Hornsea Project Three
Offshore Wind Farm

Appendix 24 to Deadline 6 submission - Proposed Use of
Temporary Working Areas for Micrositing: Implications for
Environmental Statement

Date: 8th February 2019

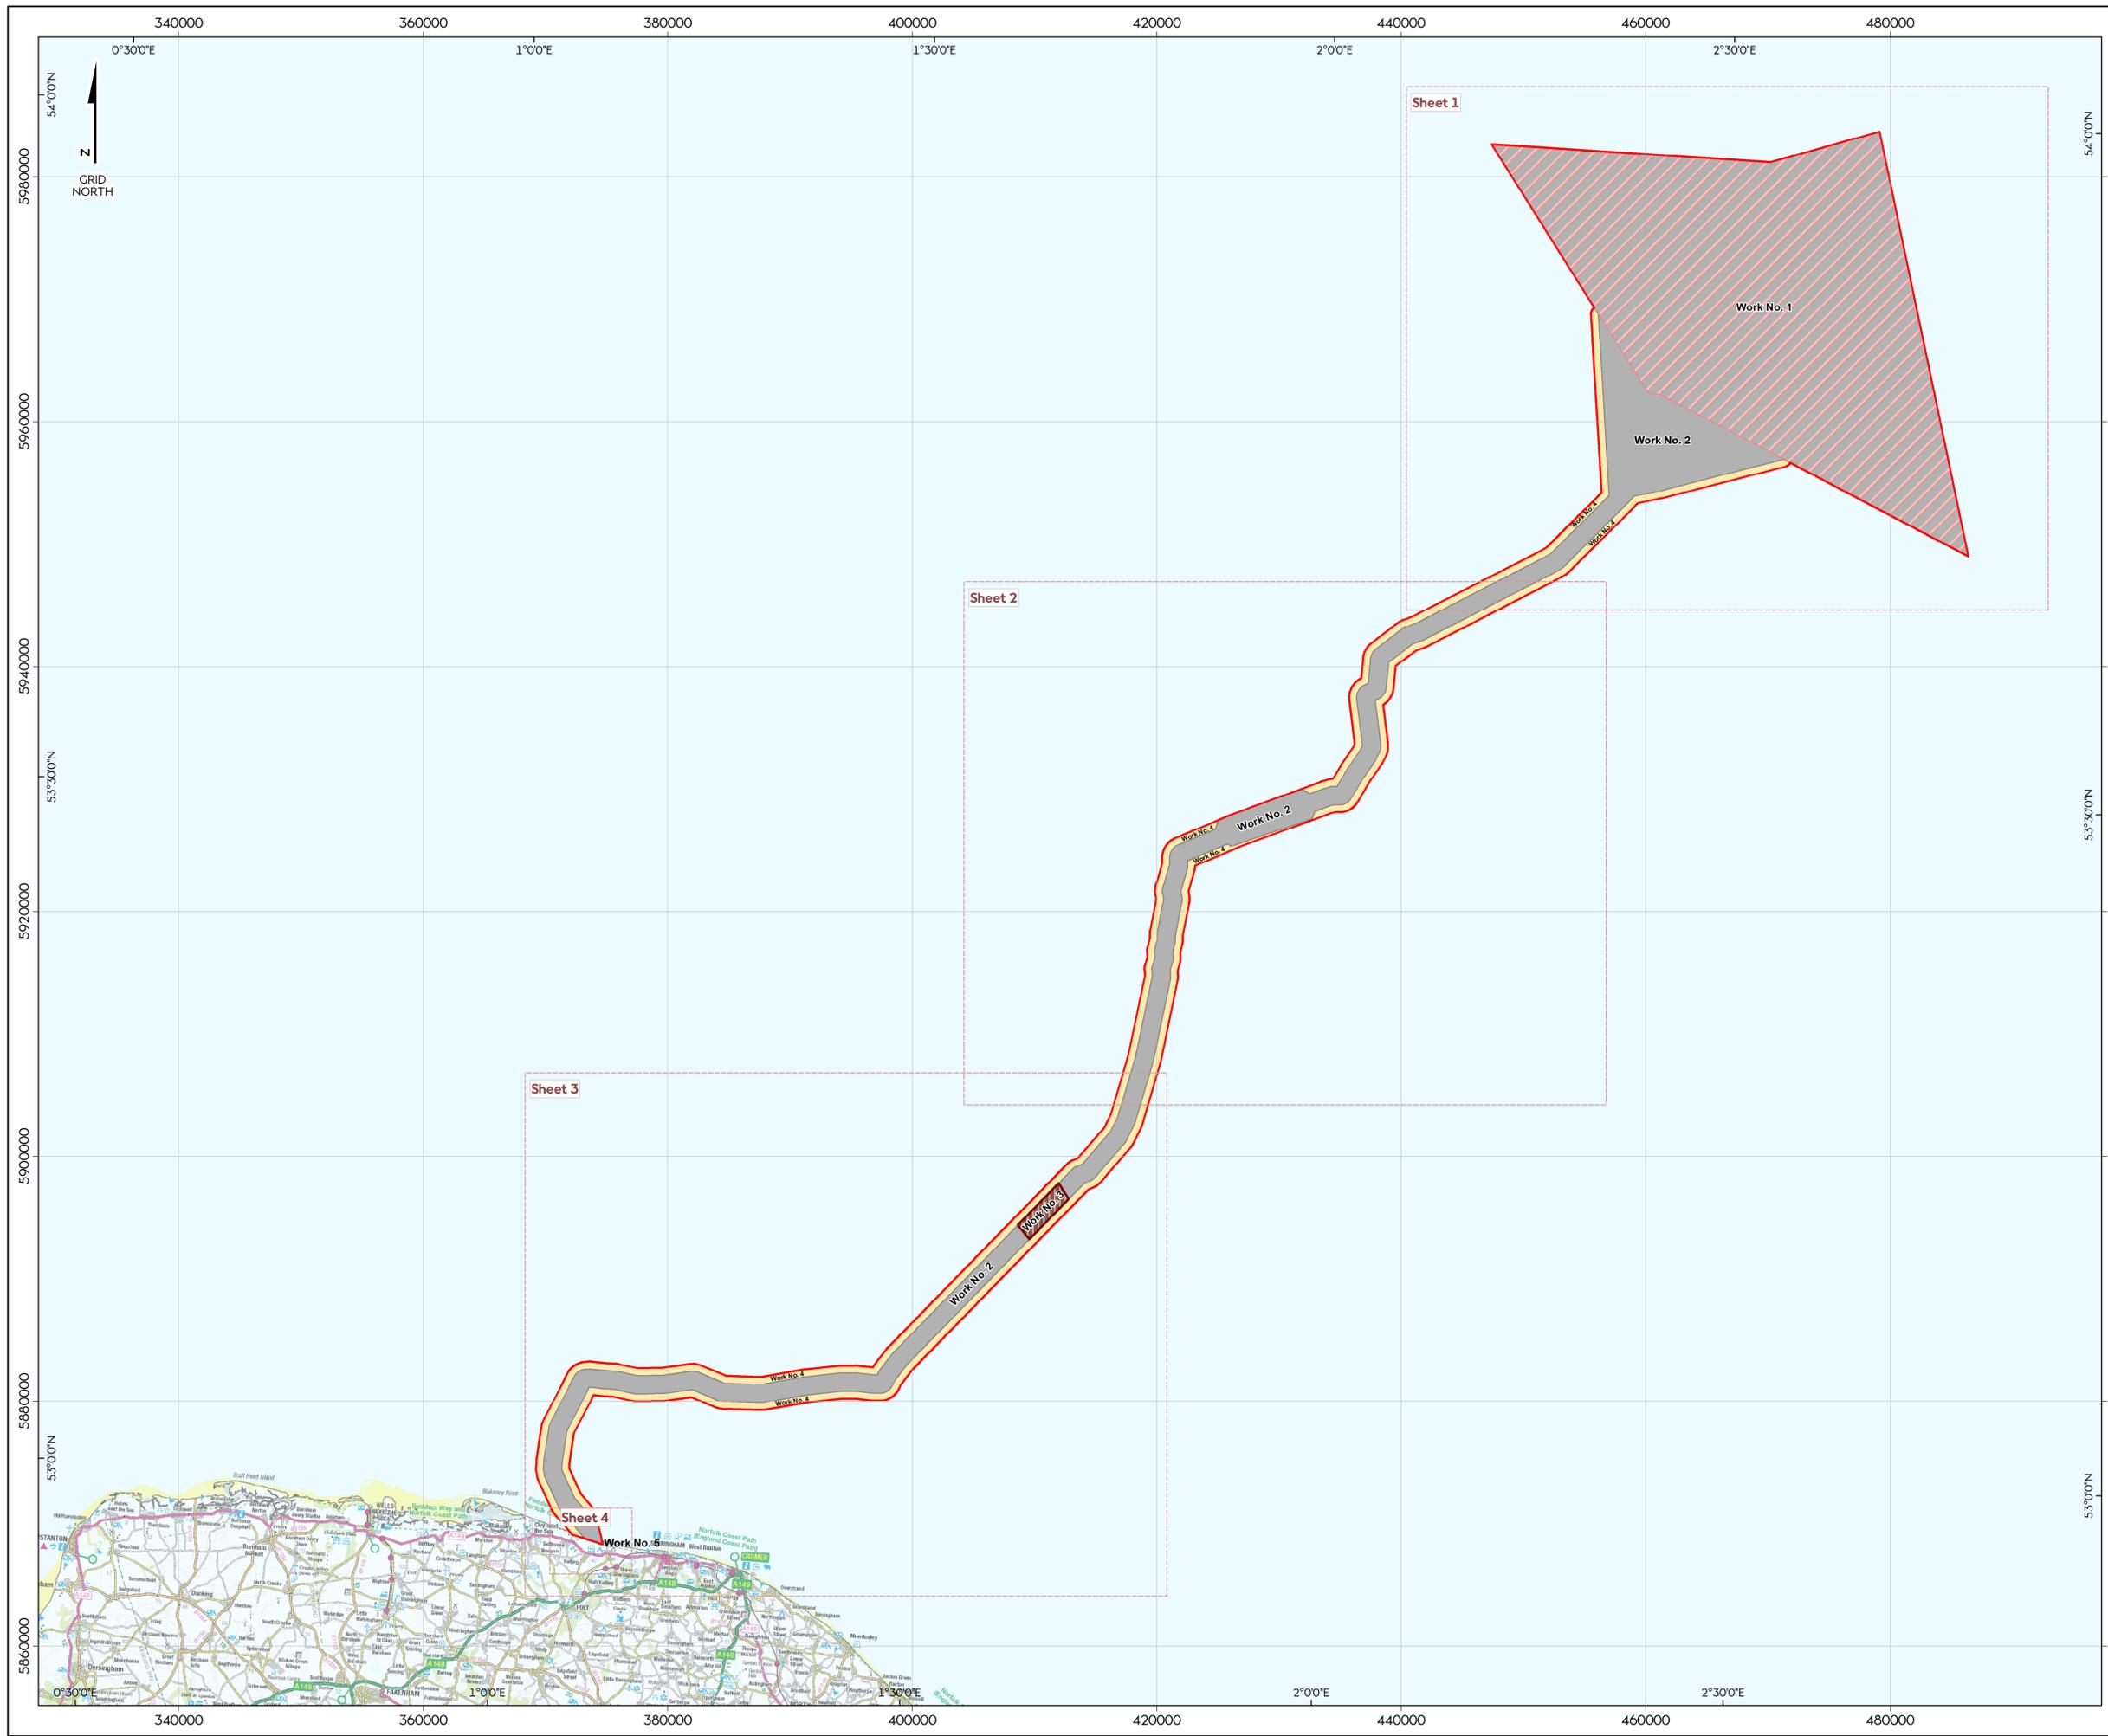
- 1.3 As shown in Figure 1.1 and Figure 1.2 between KP95.5 and KP103.5 of the offshore cable corridor, cables may be installed within the temporary working areas to the north and south of the offshore cable corridor. The southern boundary has been aligned with the boundary of the licenced aggregate extraction area 484.

- 1.4 This change will not result in an extension of the temporary works area to the north or south. All cable installation will therefore occur within the Development Consent Order (DCO) boundary and therefore there will be no change in the order limits for the project. This proposed change is also shown in the Draft Work Plans presented in Annex A to this document. This change will not necessitate a change to the footprint of the cable installation or any other project parameters (e.g. maximum length of offshore cables, seabed disturbance from cable installation or volumes/footprint of cable protection measures)
